Property Location: 133 FRANKLIN AVE Application No: HPC2021-002 Application Date: 01/05/2021

# HISTORIC PRESERVATION COMMISSION CERTIFICATE OF APPROPRIATENESS - INCOMPLETE

#### APPLICATION REVIEW NOTES:

<sup>\*</sup> DETAILS PROVIDED

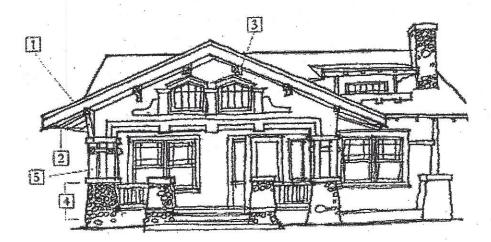
- 1. You will need to remove more siding, the part that you did remove is not enough to make a determination. You will need to submit a condition report (this includes pictures and labeling) of the siding and once this is removed we will need to do an on site inspection, which we can schedule. You can just let me know when the siding is removed and a member can go out and look at it. They typically do this on Tuesdays.

THE SIDING HAS BEEN REMOVED FURTHER IN THE SAME LOCATION AS PREVIOUSLY SHOWN FOR YOUR EXAMINATION. THE CLAPBOARD SHOWN APPEARS TO BE ORIGINAL TO THE STRUCTURE. WE ARE PROPOSING TO REPLICATE THE EXISTING SIDING WITH LIKE SHAPE AND SIZE AS PER HPC GUIDELINES.

IF THIS IS UNALLOWABLE, WE WILL REPAIR THE EXISTING AND PAINT AS REQUIRED.

IT IS OUR AIM TO RESTORETHE HOUSE TO THE ORIGINAL CRAFTSMAN STYLE DETAIL AS PER HPC GUIDELINES.

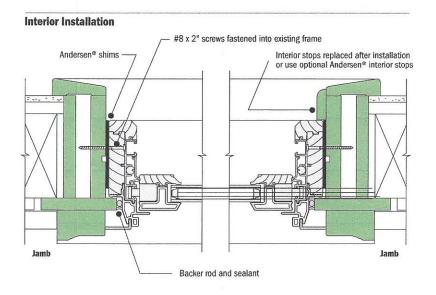
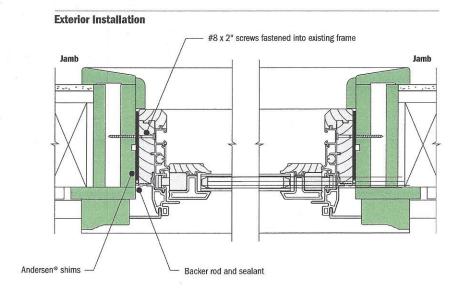
- 2. The windows must be simulated divided light. You will also need to submit a condition report on these windows if they are original.
- 3. Please provide a catalog cut of the garage door.

#2-THE PROPOSED WINDOWS ARE A SIMULATED DIVIDED LITE AS PER THE GUIDELINES PROVIDED. PLEASE FIND THE CATALOGUE TECH SECTION. WE ARE PROPOSING TO MATCH THE EXISTING GRID PATTERN OF 3 OVER 1. ALL OF THE WINDOWS ARE NOT ORIGINAL; HOWEVER, WE ARE PROPOSING TO USE THE 3 OVER 1 GRID PATTERN ON THOSE WINDOWS AS WELL.

THE CONDITION OF THE WINDOWS IS AS FOLLOWS.

<sup>\*</sup>ALL OF THE WINDOWS ARE A SINGLE PANE GLASS

<sup>\*</sup>ALL OF THE WINDOWS ARE PAINTED SHUT AND THEY ARE IN AN INOPERABLE CONDITION ON ONE OR BOTH SASH.

37015 3/0 x 8/0 Customer Layout

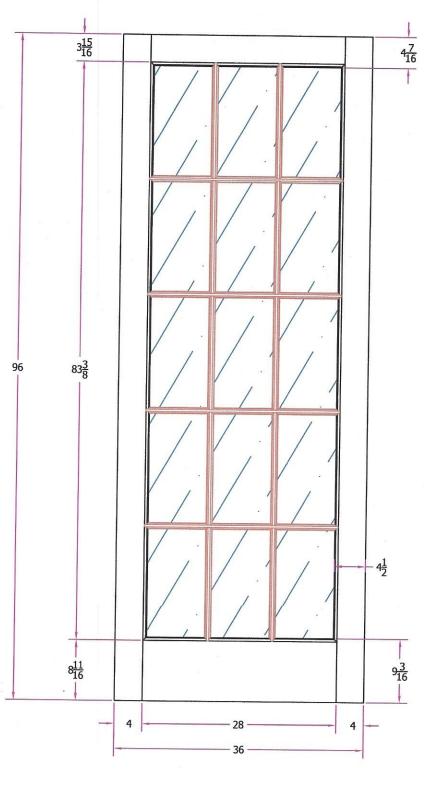
- 4. Please provide a catalog cut for the 15 lite French entrance door.
- 5. Please provide a condition report on the chimneys. We will also need to do an on site inspection for this.

\*PLEASE FIND THE CATALOGUE INFO FOR THE 15 LITE FRENCH ENTRANCE DOOR.

\*IF THIS DOOR IS UNACCEPTABLE WE WILL JUST RESTORE THE ORIGINAL DOOR USUNG INSULATED GLASS AND PAINT AS REQUIRED.
